Interactive Discussion: Author Response to Referee #1

Assessing the feasibility of a directional CRNS-sensor for estimating soil moisture

Geoscientific Instrumentation Methods and Data Systems, Discuss., doi:10.5194/gi-2021-18

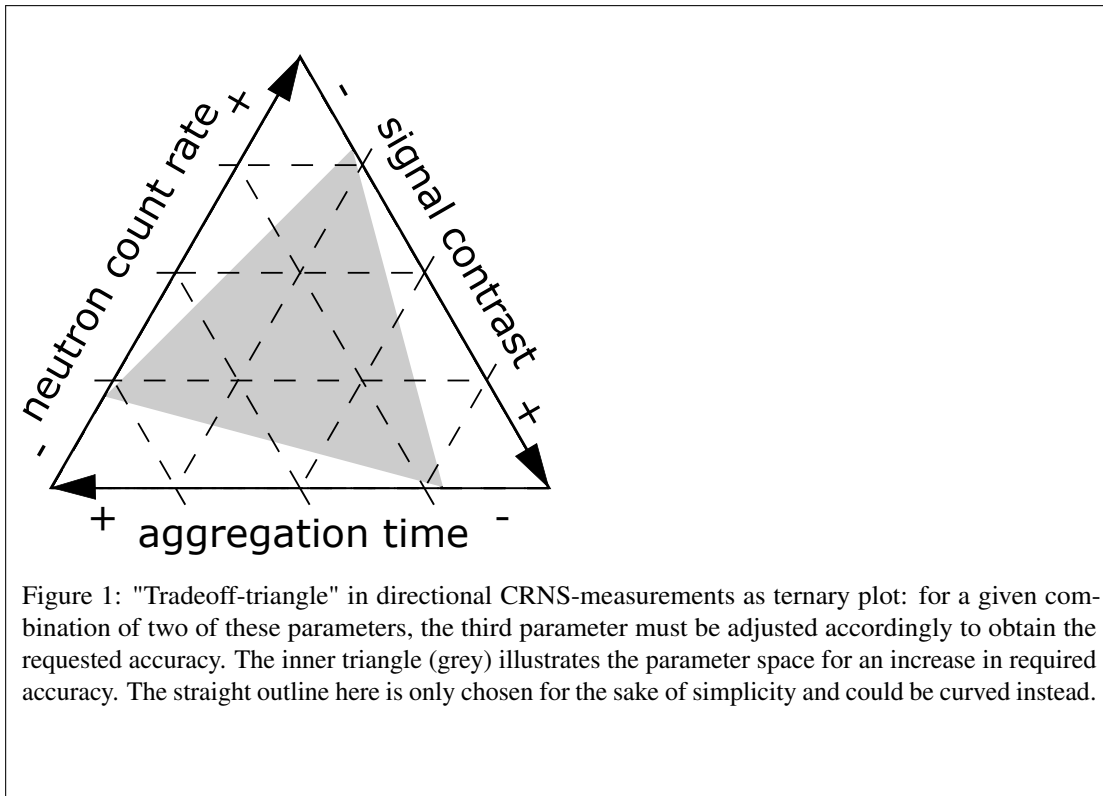
RC: *Line 109. Emphasize that these settings are in the detector electronics. Can you add the model of the neutron pulse analyzer from Quaesta?*

AR: We changed the wording to "... threshold settings in the electronics " to underline the fact. There are various forms of non-neutron signals. Some of them can be cut by setting lower and upper thresholds on the detected pulse energy. In the case of radioimpurities their signatures are often indistinguishable from neutrons in case their energy lies in the range of those of neutron conversion products. With usual electronics, independent of the manufacturer, such cannot be discriminated against. They form a plateau 'under' the neutron events.
